3 Detailed description of change

Product Change Notification					PCN for PG05 (Change Config.Code)		
owner	creation date	release date	released by	change order no	rev	page	D10-024-451
hollenpe	28.03.2018	05.07.2018	limachcl	2015365	A	1 of 2

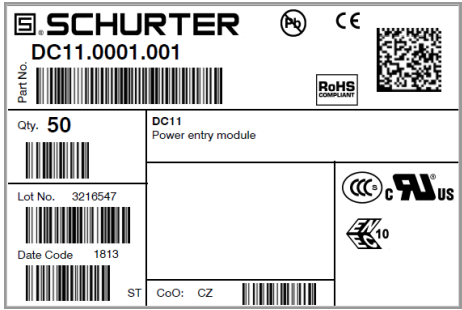
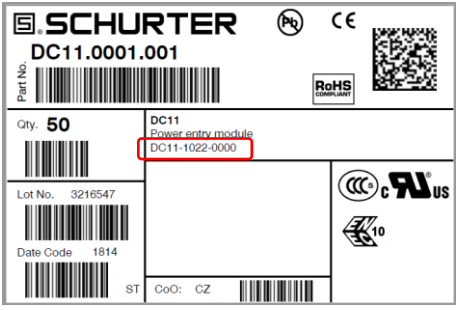
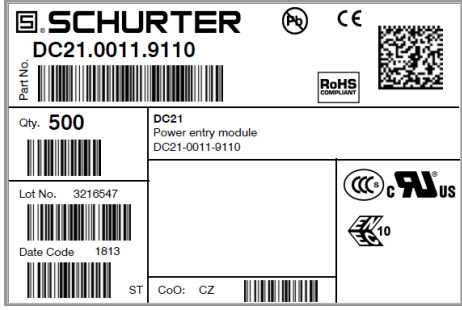
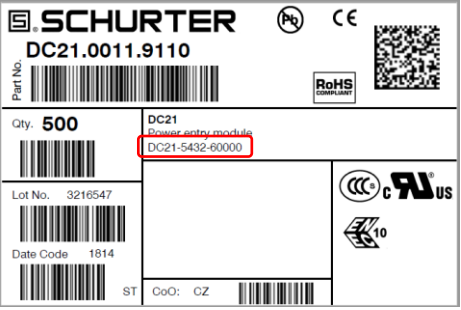
The configuration code has been modified. This change affects all the configuration codes depicted in documents by SCHURTER AG which refer to the affected products. This includes the packaging label and documents created in SAP(e.g. invoices, order papers, etc.). None of the part numbers will be altered and will remain the same as before. To secure a unique reference, SCHURTER asks the customer to refer to the part number for future correspondence. The configuration code can be used as a second reference to identify the technical properties of a product. Please check the list "Change of configuration code PG05_06_07" for a reference of the old and new configuration code with the according part number. You can find said list in the SCHURTER Partner Service on our website.

Old packaging label (without old CC)	New packaging label (with new CC)
 <p>Part No. DC11.0001.001 Qty. 50 Lot No. 3216547 Date Code 1813 DC11 Power entry module CoO: CZ</p>	 <p>Part No. DC11.0001.001 Qty. 50 Lot No. 3216547 Date Code 1814 DC11 Power entry module DC11-1022-0000 CoO: CZ</p>
Old packaging label (with old CC)	New packaging label (with new CC)
 <p>Part No. DC21.0011.9110 Qty. 500 Lot No. 3216547 Date Code 1813 DC21 Power entry module DC21-0011-9110 CoO: CZ</p>	 <p>Part No. DC21.0011.9110 Qty. 500 Lot No. 3216547 Date Code 1814 DC21 Power entry module DC21-5432-60000 CoO: CZ</p>
